- Class 100 A -

November 1886

Dun. Rep. 5037.

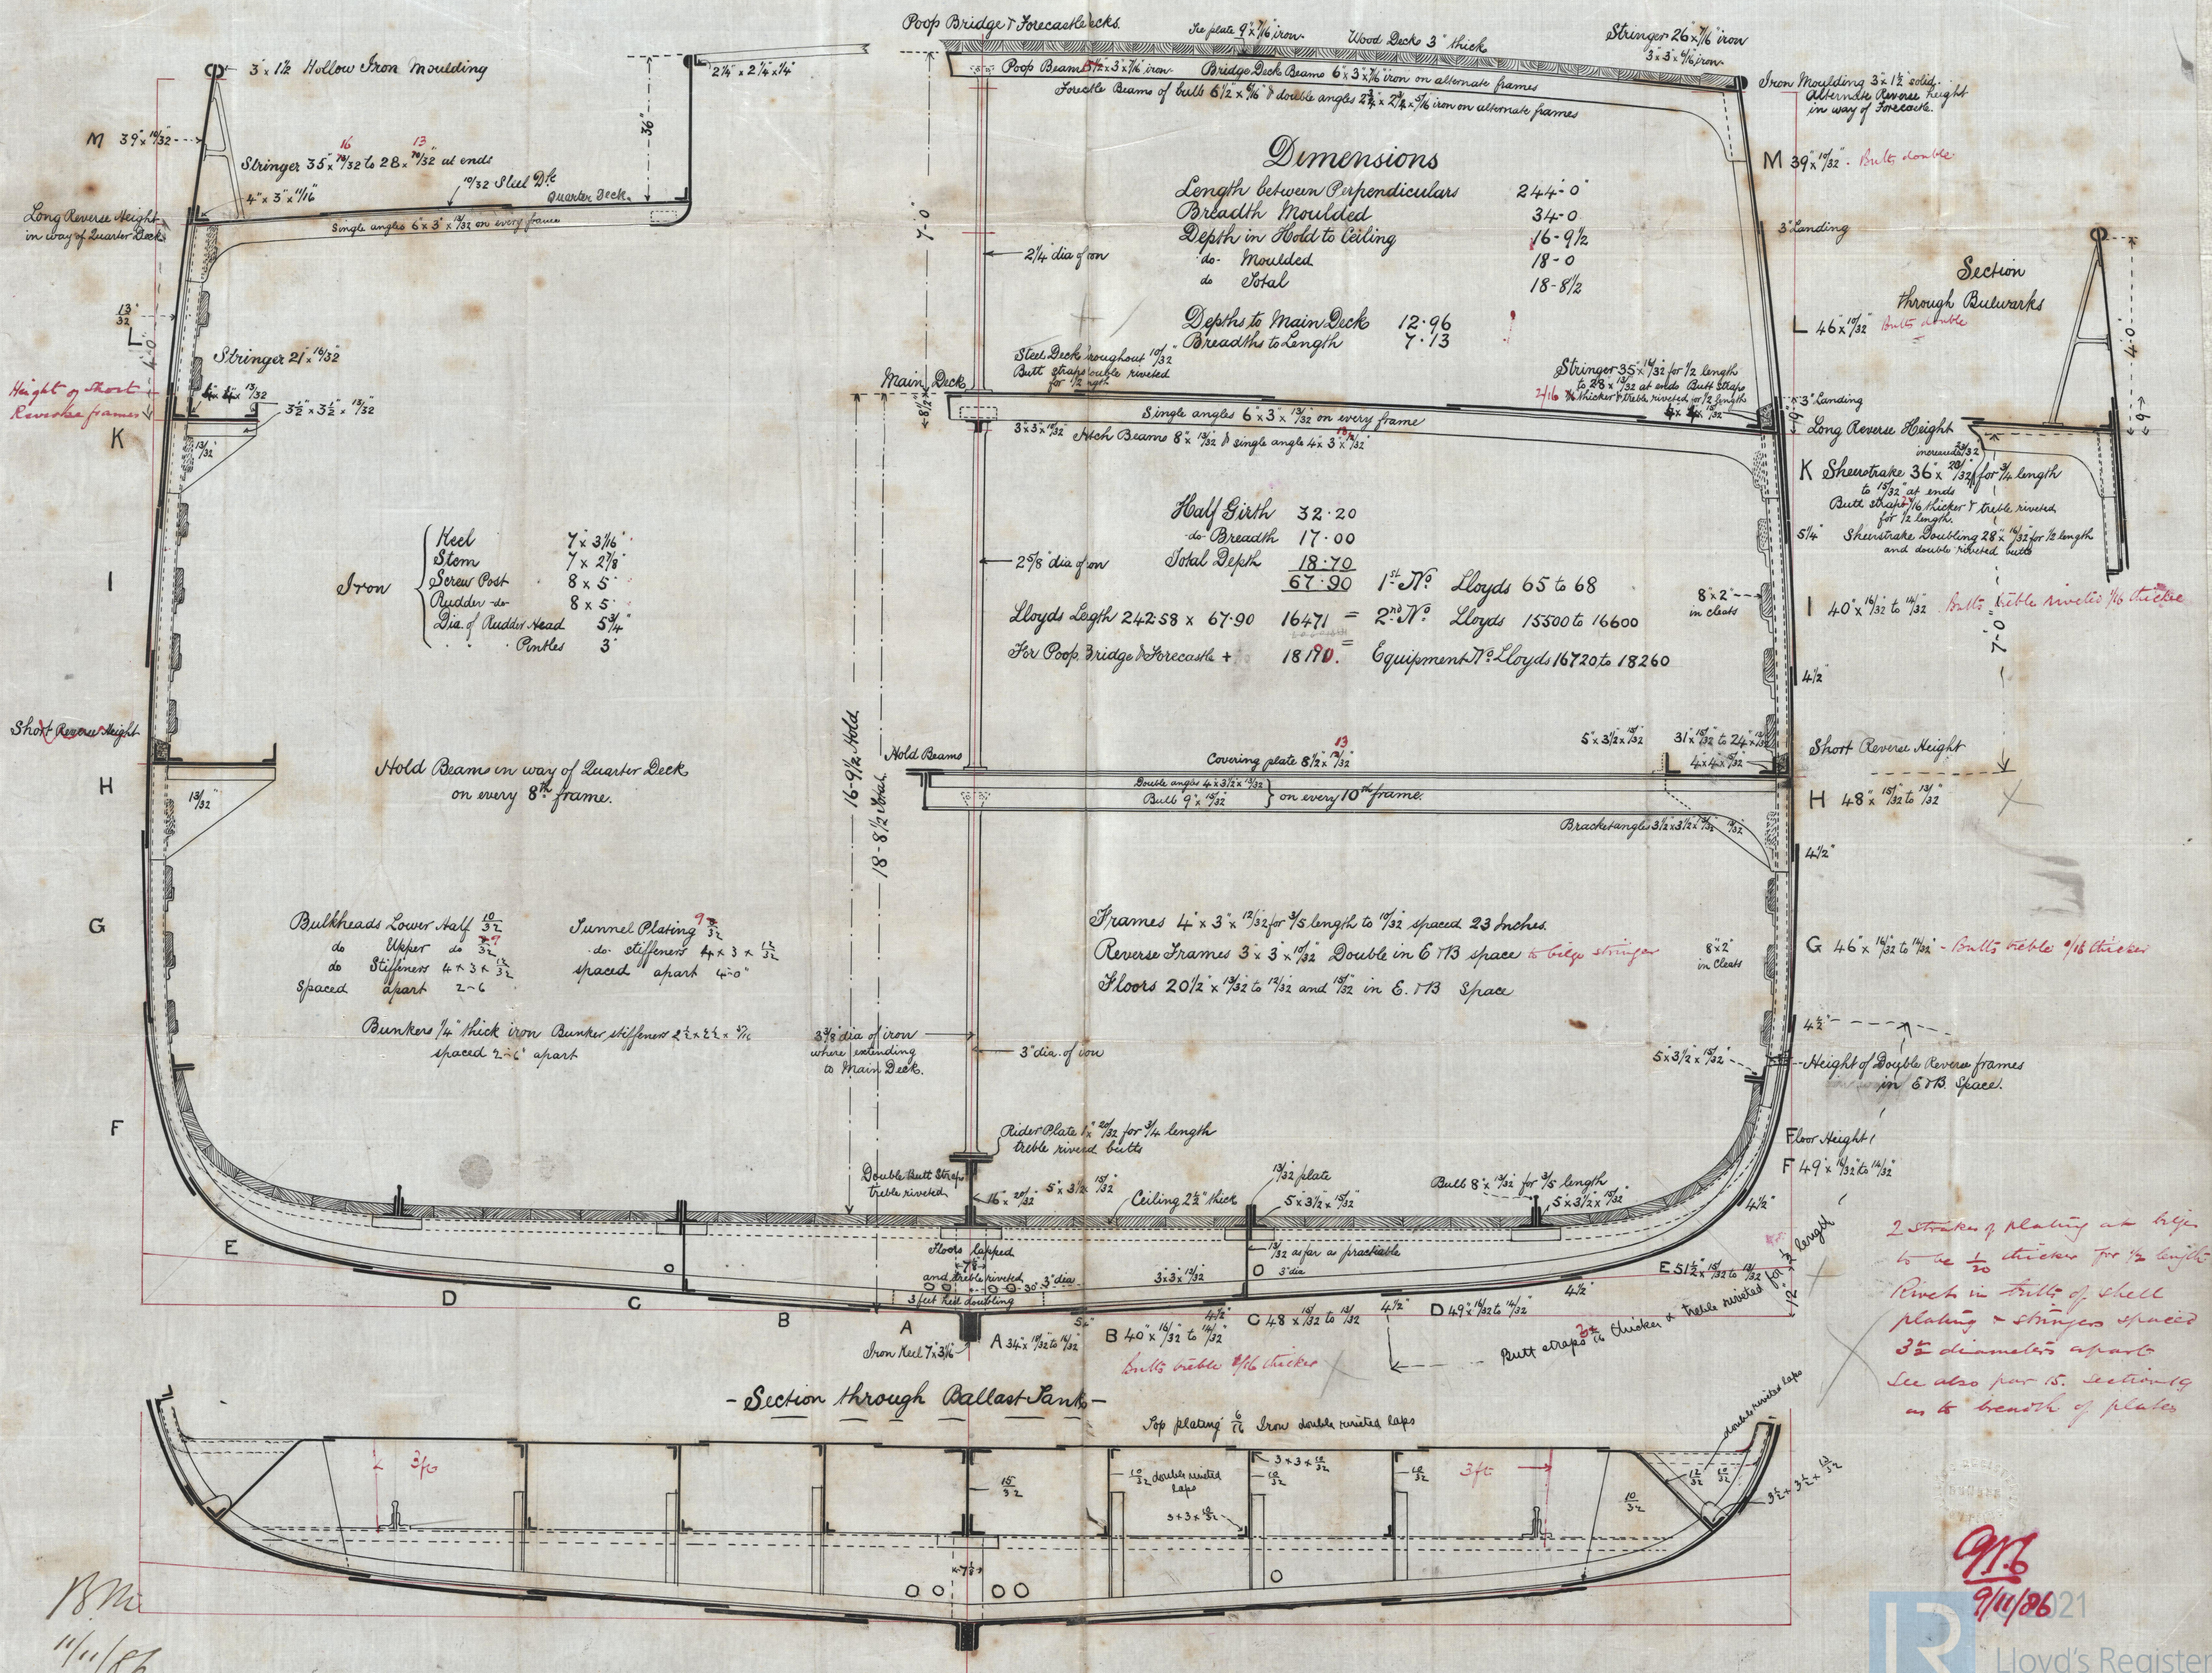
2 Stripes of plating at right  
to be  $\frac{1}{20}$  thicker for  $\frac{1}{2}$  length  
Rivets in middle of shell  
plating & stringers spaced  
 $3\frac{1}{2}$  diameters apart  
See also par 15. Section 19  
on to breadth of plates
